SUBMITTAL REVIEW

LOCATION — INTERSTATE 91
BRIDGE — 6M&S
PROJECT — AC IM 091-1(50)
—
P.O. NO. — BRATTLEBORO
DESIGNER — T.Y. LIN INTERNATIONAL
CUSTOMER — BECK & BELLUCCI, INC.

DESCRIPTION: VERSIFLEX ELASTOMERIC BEARING
WINDHAM CO., VT

ELASTOMERIC BEARING

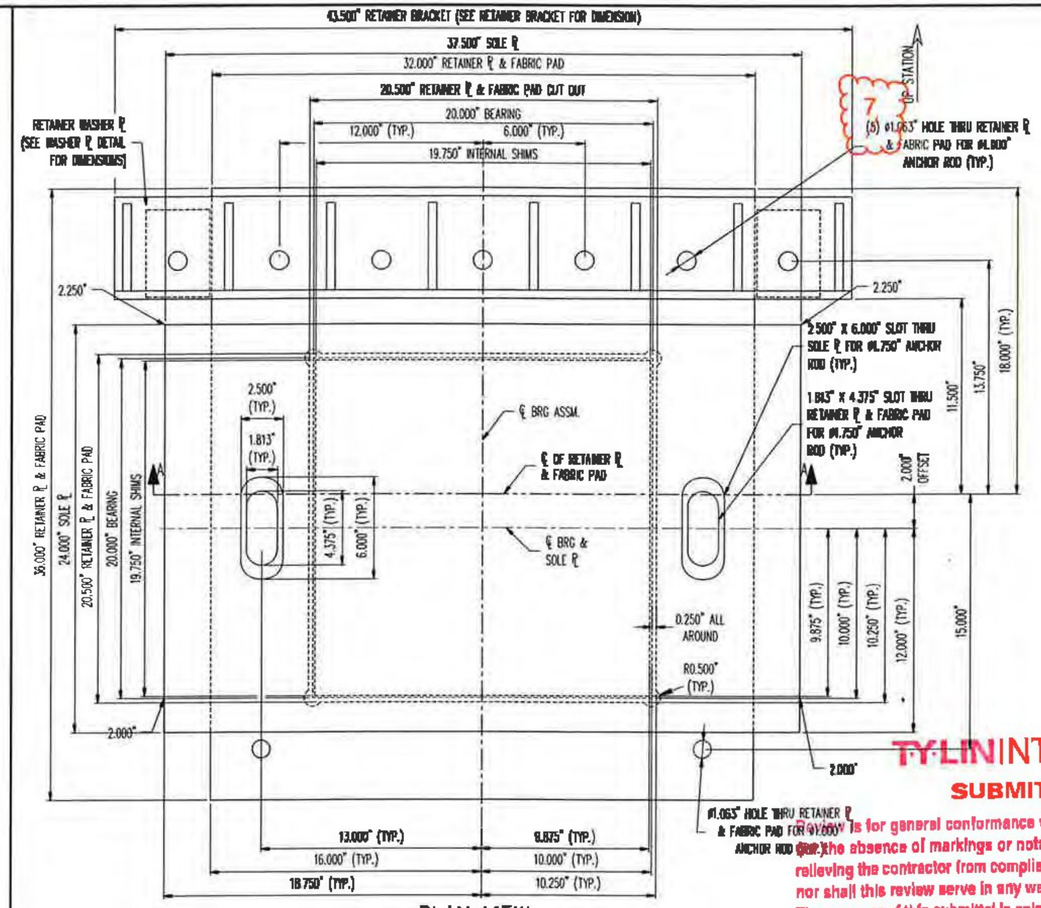
Build to shear modulus 130 psi

PLEASE VERIFY SEE TRANSMITTAL

ANCHOR ℄ DETAIL

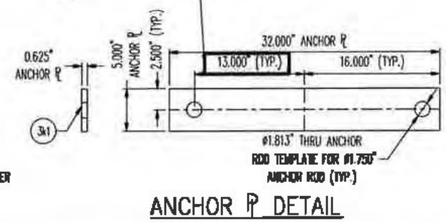
Add 3.500"x5.125" Fabric Pad for under washer PL.
